Project No. 1339-351-11-02-12
October 18, 2016

Re: Supplemental Submittal
Camelot Landfill Permit Amendment Application – Denton County
Municipal Solid Waste (MSW) Permit No. 1312B
CN600131676/RN101479038

**CAMELOT LANDFILL
CITY OF LEWISVILLE, DENTON COUNTY
TCEQ PERMIT NO. MSW-1312B**

MAJOR PERMIT AMENDMENT APPLICATION

PROPOSED LANDFILL COMPLETION PLAN
(TCEQ PERMIT NO. MSW-1312B)

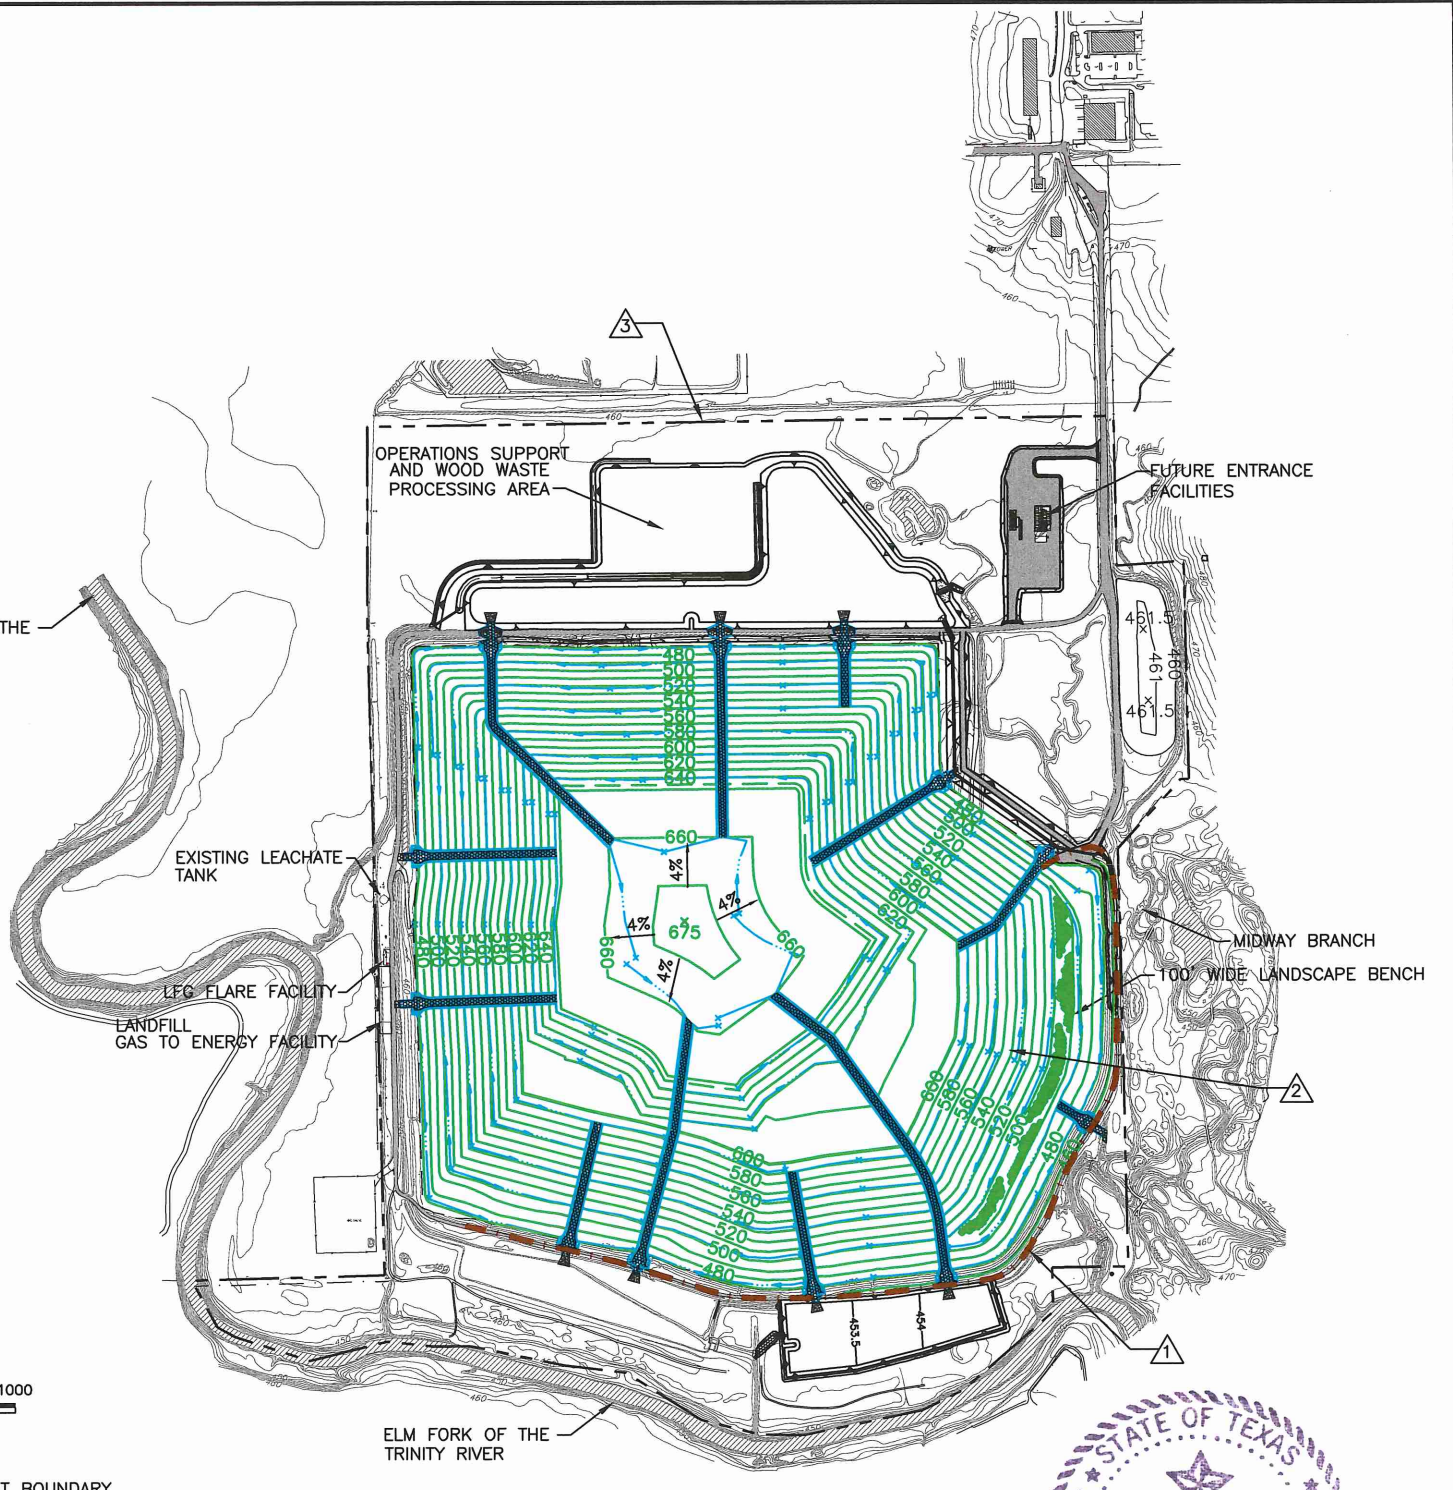
1. REVISED SLURRY WALL TO EXISTING LOCATION.
2. UPDATED FINAL COVER CONTOURS.
3. UPDATED PERMIT BOUNDARY INFORMATION.

PROPOSED EXCAVATION PLAN
(TCEQ PERMIT NO. MSW-1312B)

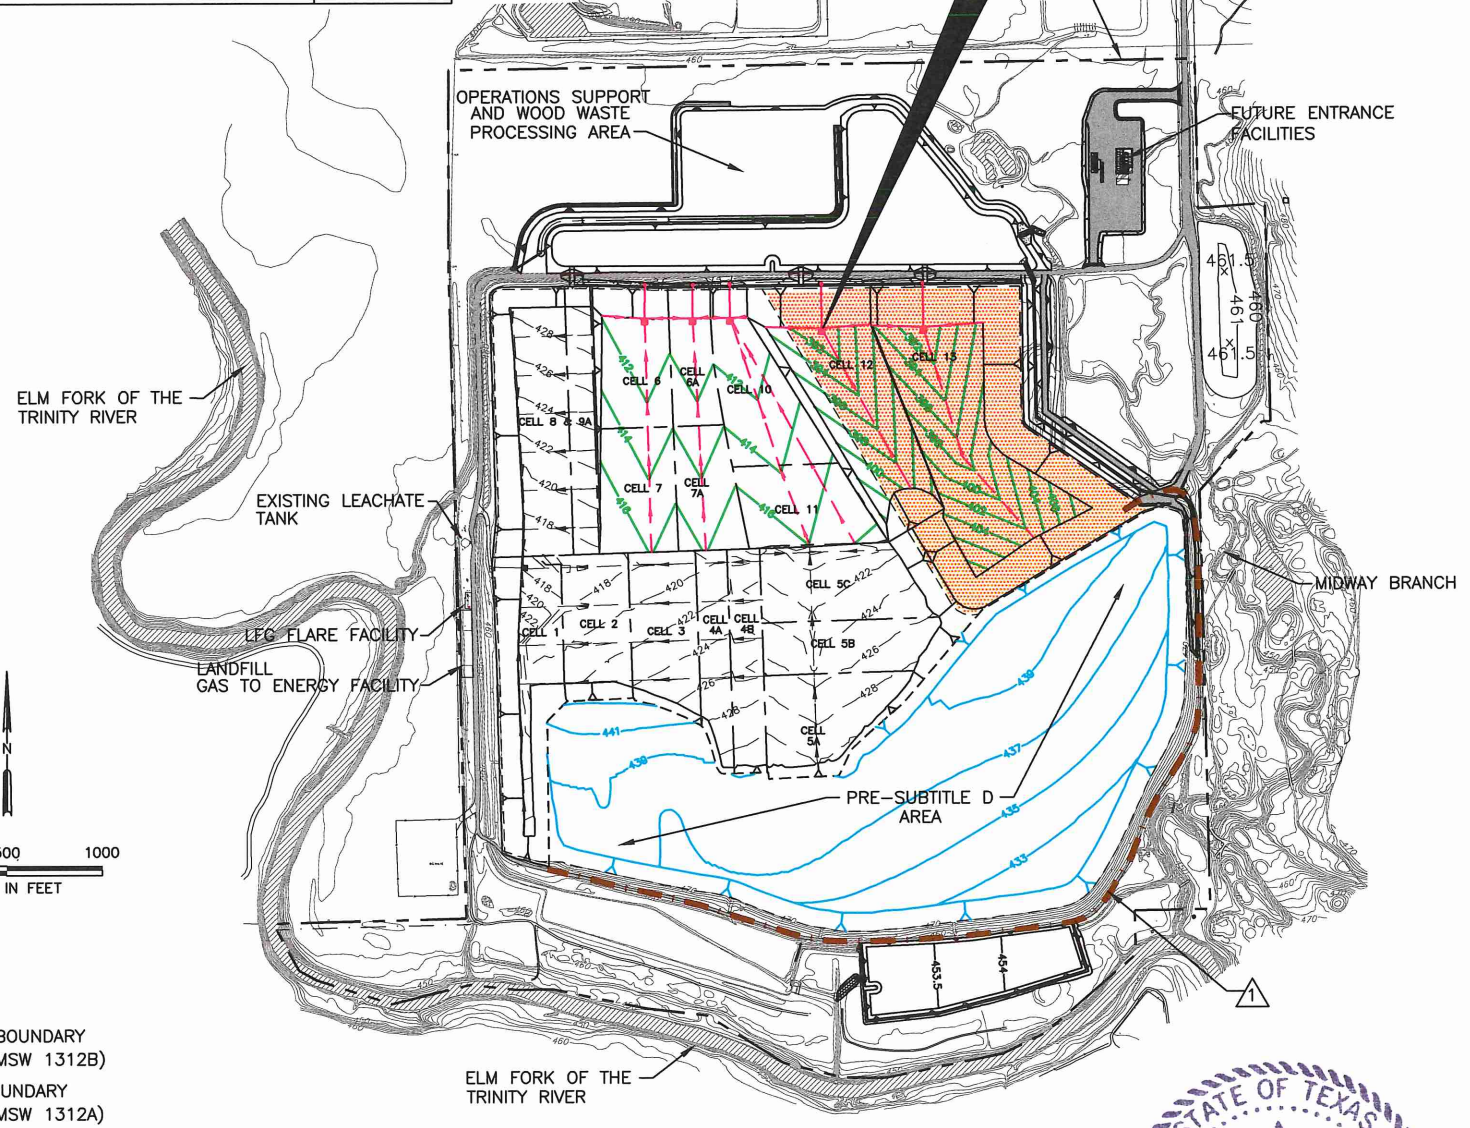
- REVISED TO SHOW EXISTING LOCATION OF SLURRY WALL.
- UPDATED PERMIT BOUNDARY INFORMATION.

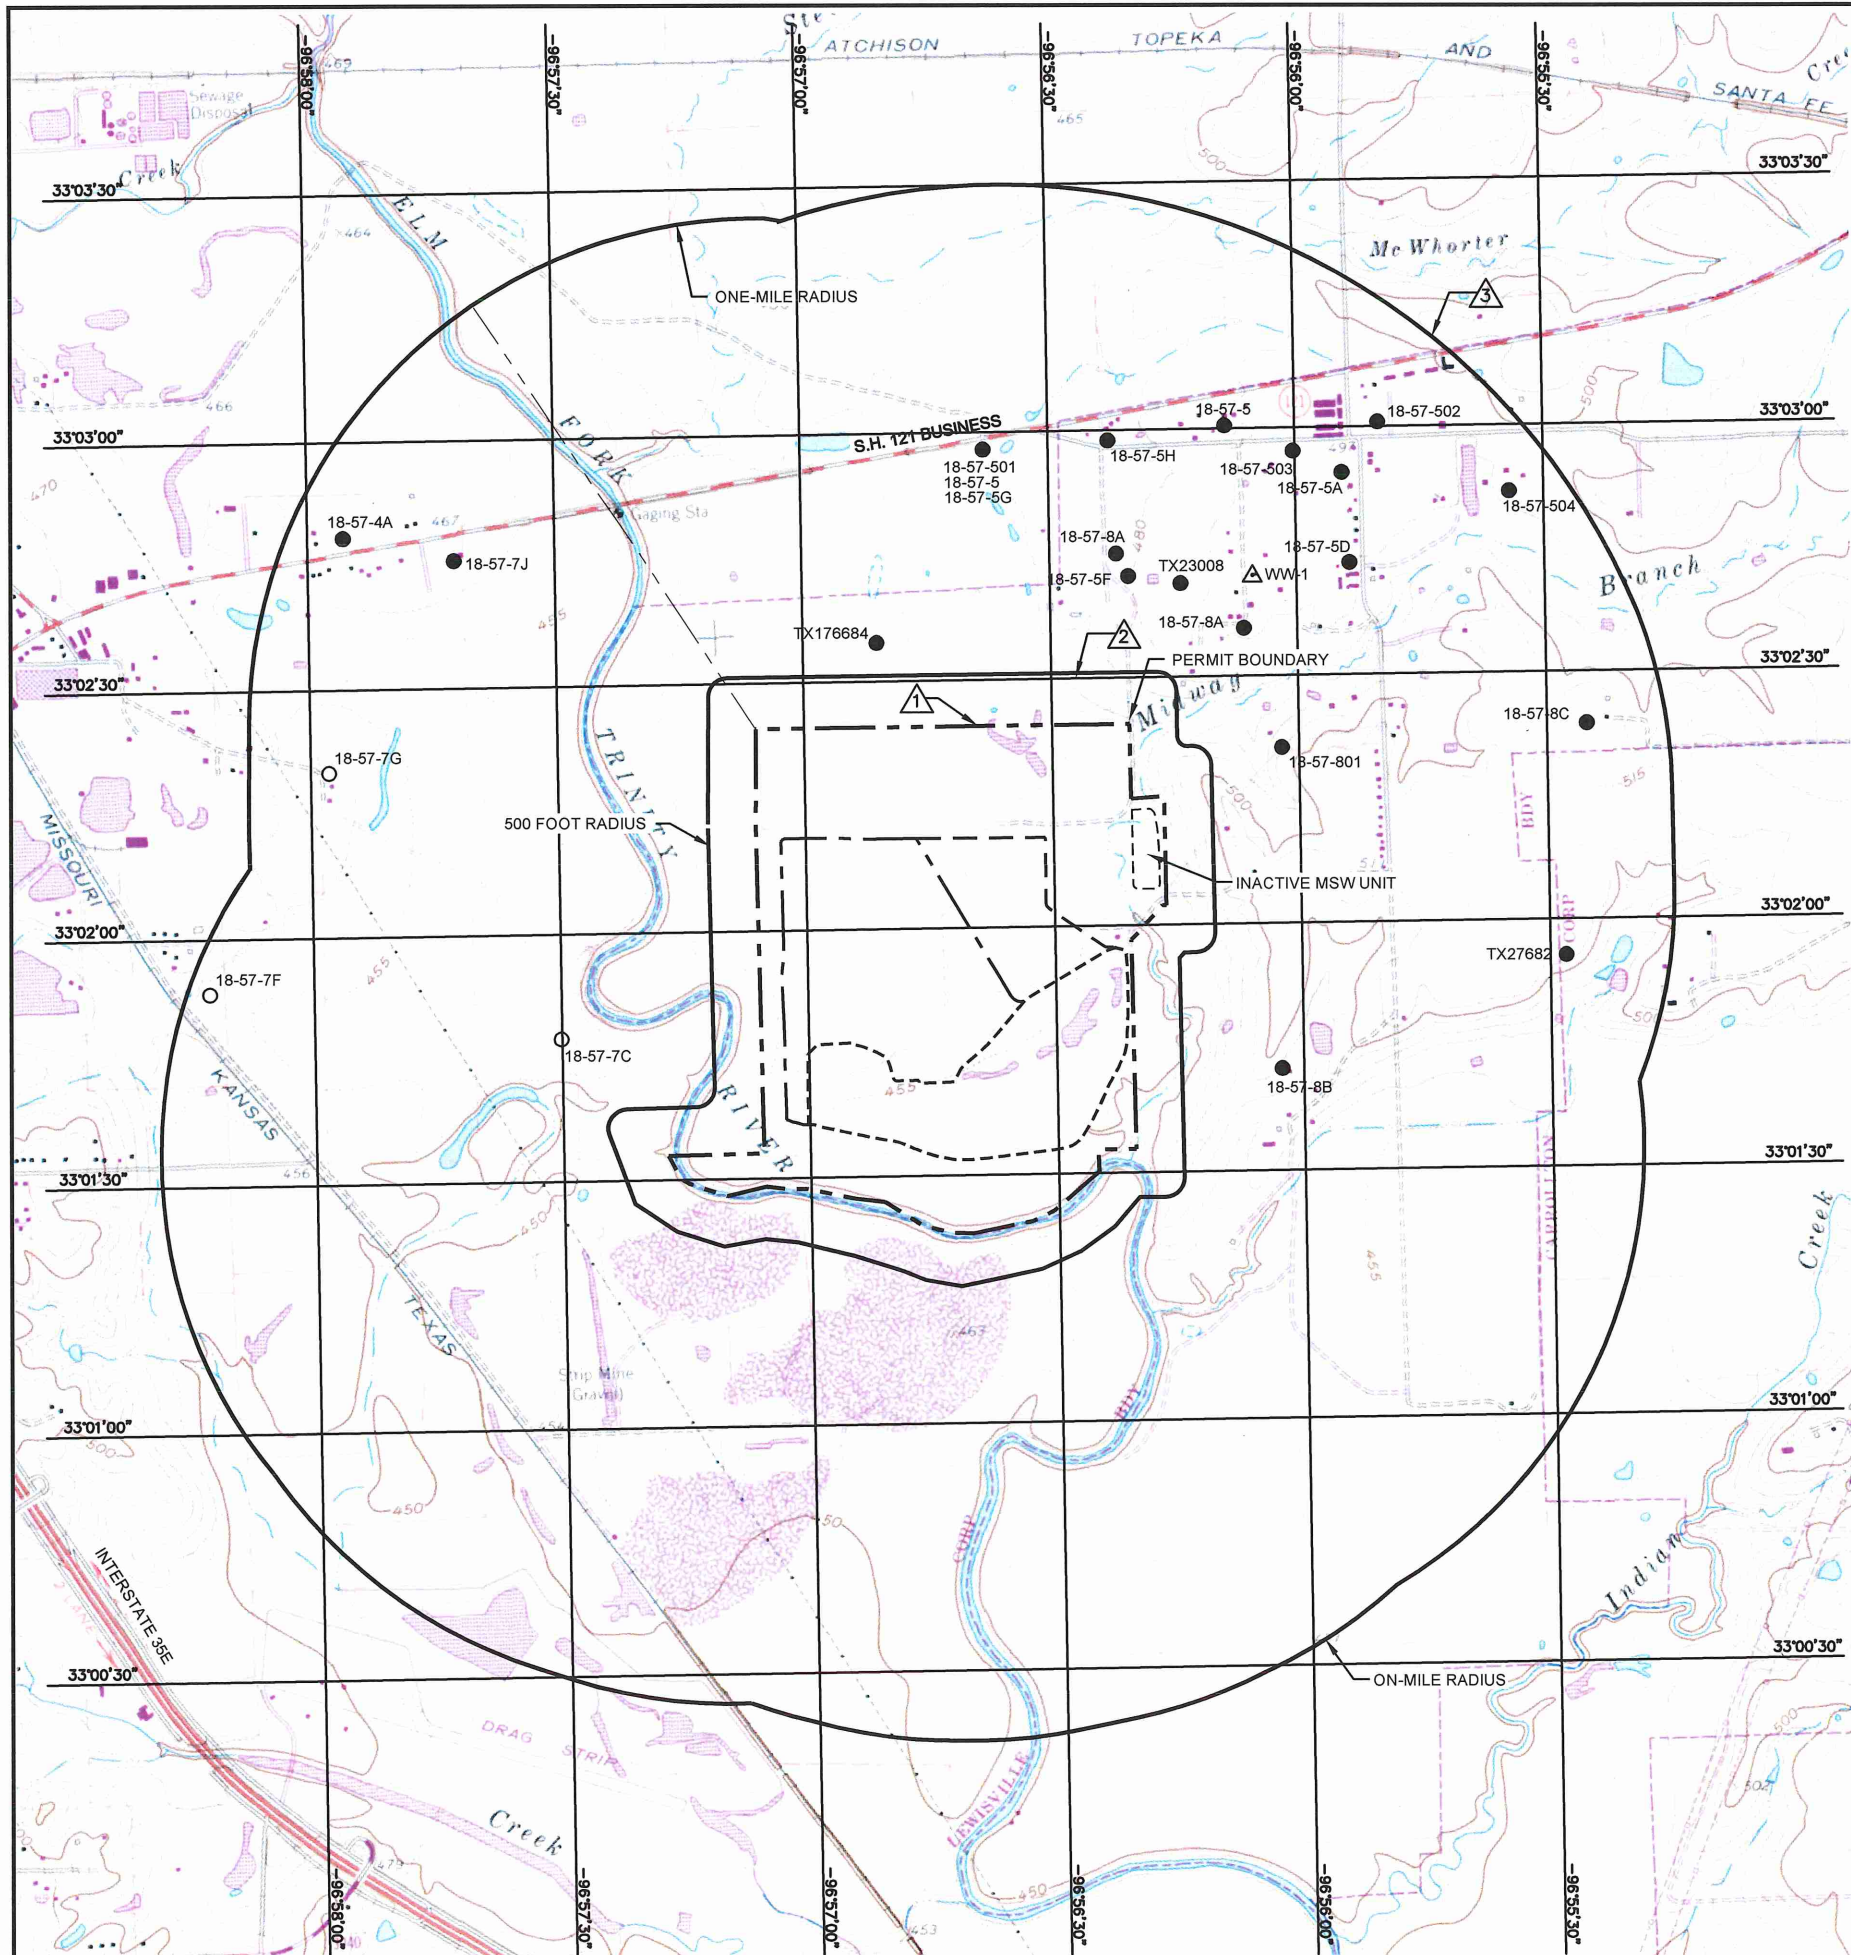
- LIST OF REVISIONS:**
- UPDATED PERMIT BOUNDARY.
 - UPDATED ONE-MILE RADIUS.

O:\1339\351\EXPANSION 2009\PARTS 1-11\5.1-LANDOWNERS MAP.dwg, 10/17/2016 3:06:48 PM, r.morris, 1:2

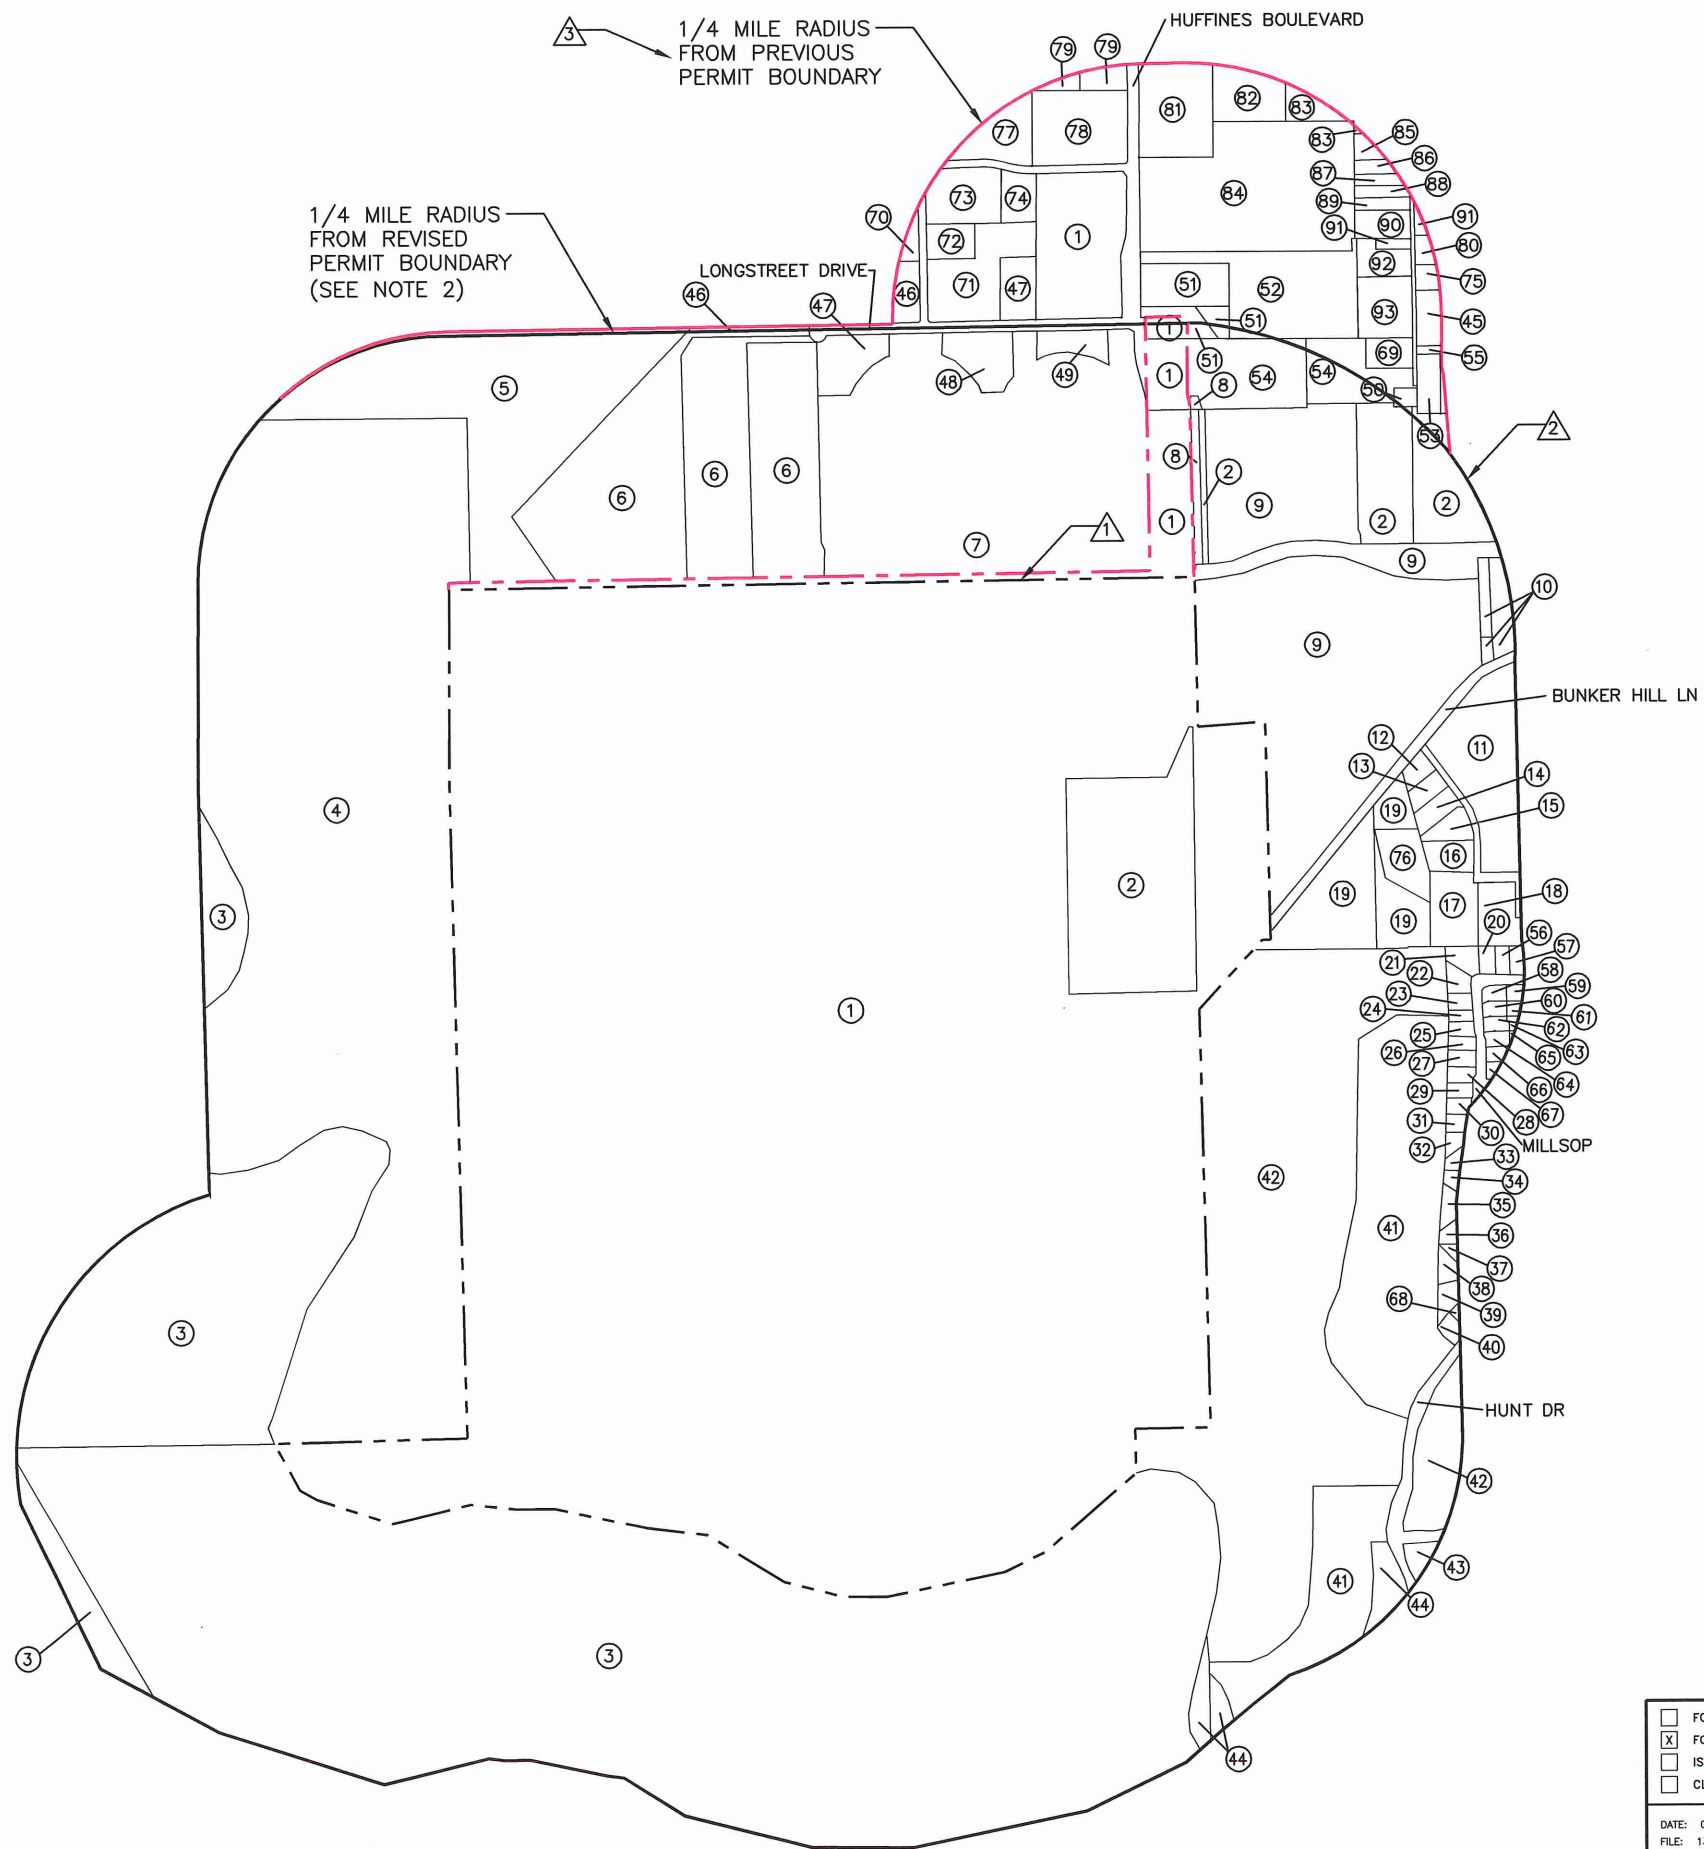
- LIST OF REVISIONS:**
- UPDATED PERMIT BOUNDARY.
 - UPDATED 1/4 MILE RADIUS.
 - ADDED CALLOUT FOR PREVIOUS 1/4 MILE RADIUS AND PERMIT BOUNDARY.
